Technical Service Information

SATURN TAAT FALLS OUT OF DRIVE AT A STOP

Figure 1

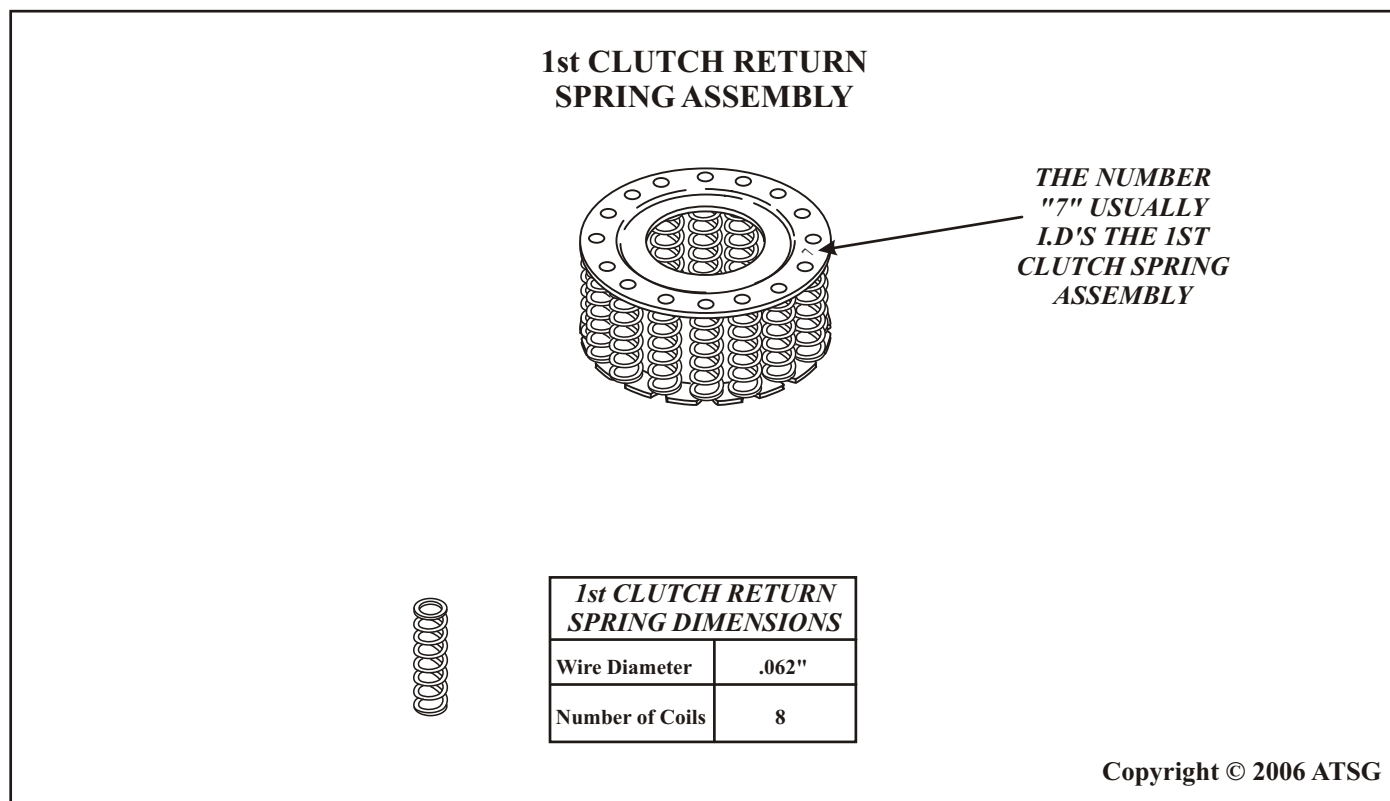
CAUSE: The cause may be, that during overhaul, the 2nd, 3rd or 4th Clutch return spring assembly was mistakenly used in place of the 1st Clutch spring assembly. When this happens, the 1st Clutch can not fully engage until line pressure is increased. Refer to Figure 1 and 2 to compare the 1st Clutch return spring assembly to the 2nd, 3rd and 4th. Notice that the coil diameter of the springs, on 2nd, 3rd and 4th are approximately .010" larger and the number of coils are one more than the 1st which makes them stronger.

CORRECTION: Refer to Figure 1 to identify the 1st Clutch return spring assembly, and ensure it is in the correct location.
